Re: Minor Project Refinement No. 20 for the South Orange County Reliability Enhancement Project.

South Orange County Reliability Enhancement Project CPUC Minor Project Refinement Form

Date Requested: J	uly 24, 2023	Report No.: 20			
Date Approved: Au	ugust 8, 2023	Approval Agency: California Public Utilities Commission (CPUC).			
20 (MPR-20) temp adjacent to the SD	r: The Minor Project Refinement No. orary work area is located directly G&E right-of-way (ROW) on private Talega Associates, LLC.	Location/Milepost: The MPR-20 temporary work area is located south of Avenida Pico and west of the Talega Substation in Orange County.			
acre) proposed MPI	ive Cover: The 5,130 sq. ft. (0.12 R-20 temporary work area is located pastal sage scrub (CSS).	Sensitive Resources: The MPR-20 work area is located in an area with high paleontological potential as well as low-quality CSS. See resource discussions below.			
Modification From:	☐ Permit☐ Plan/Prod☐ Mitigation Measure☐ Other:	cedure

ATTACHMENT B MPR-20 Figure

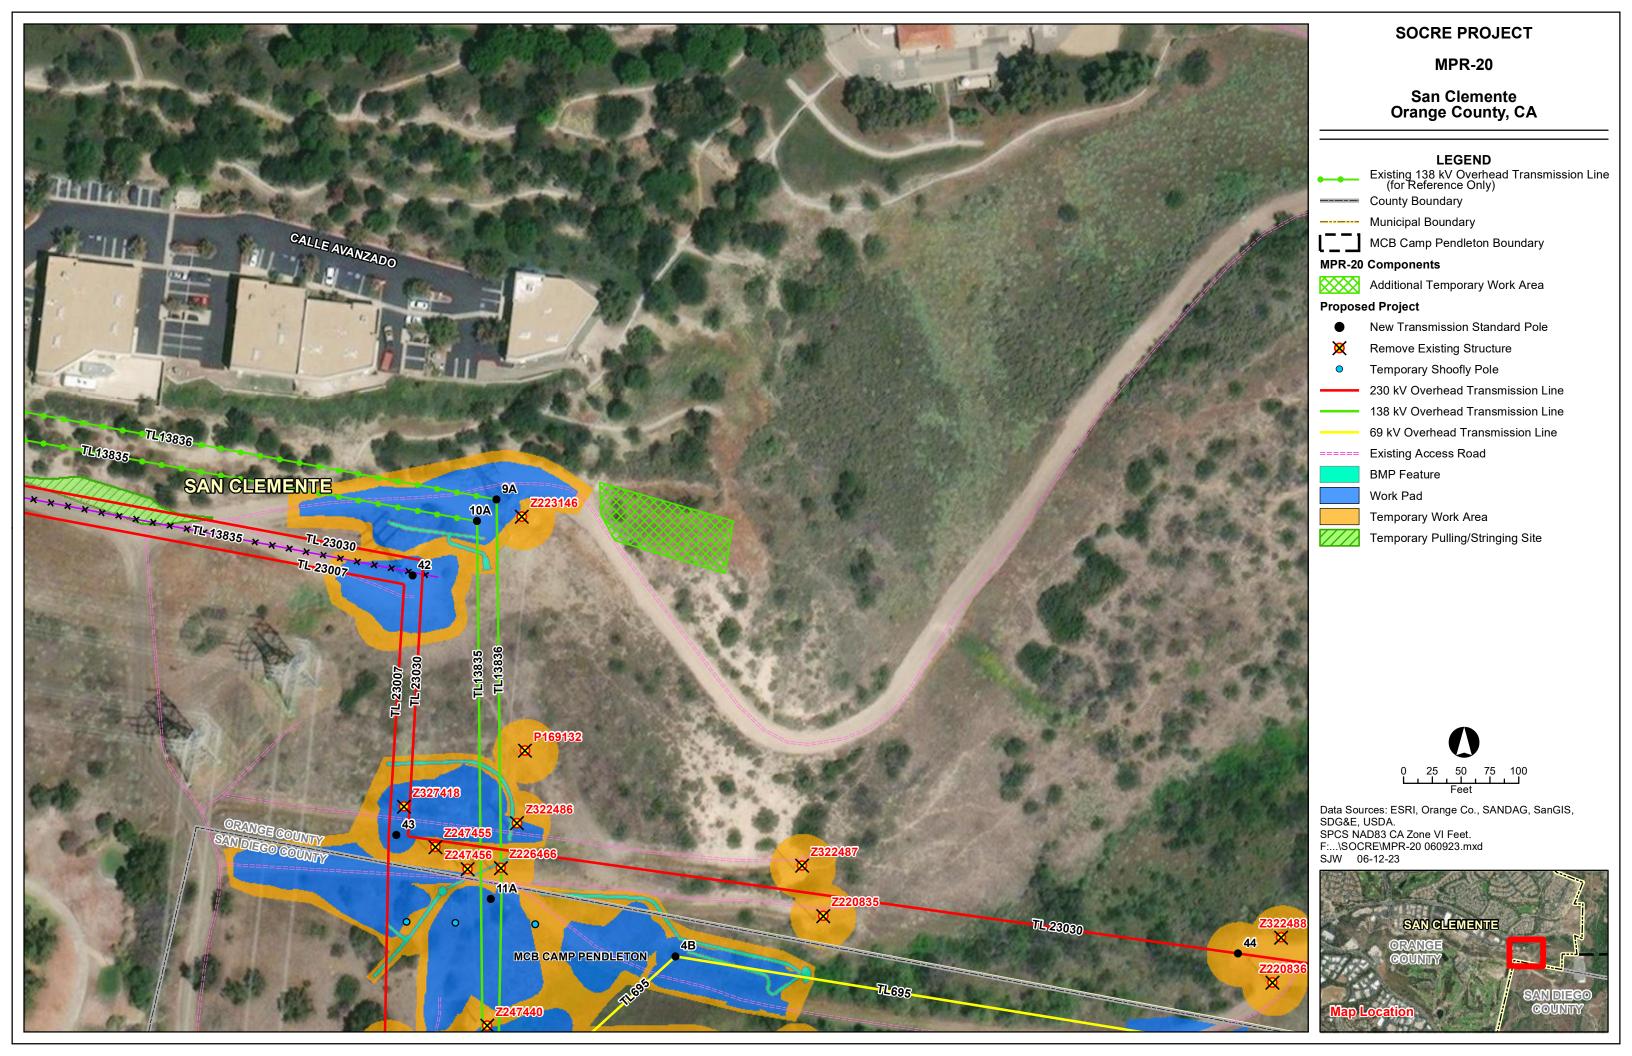
San Diego Gas and Electric (SDG&E) is requesting approval of MPR-20 for the use of a new temporary work area for the South Orange County Reliability Enhancement Project (SOCRE or Project). The new temporary work area is located immediately east of the approved Location 9A work area, as shown in **Attachment B, MPR-20 Figure**. Location 9A was previously approved in Notice to Proceed No. 7 (NTP-7). The new MPR-20 work area will total approximately 5,130 square feet (0.12 acre).

<u>Maps & Figures</u>: Refer to **Attachment B, MPR-20 Figure**, for a map of the proposed MPR-20 temporary work area location. Refer to **Attachment C, MPR-20 Site Photographs**, for pictures of the current conditions within the MPR-20 temporary work area.

- -COA-1. The extent of the MPR-20 disturbance areas will be limited to the areas shown on the figure titled "SOCRE PROJECT MPR-20" and will be used for project construction staging and related activities only during the period of project construction and restoration (anticipated to be approximately through the first quarter of 2025).
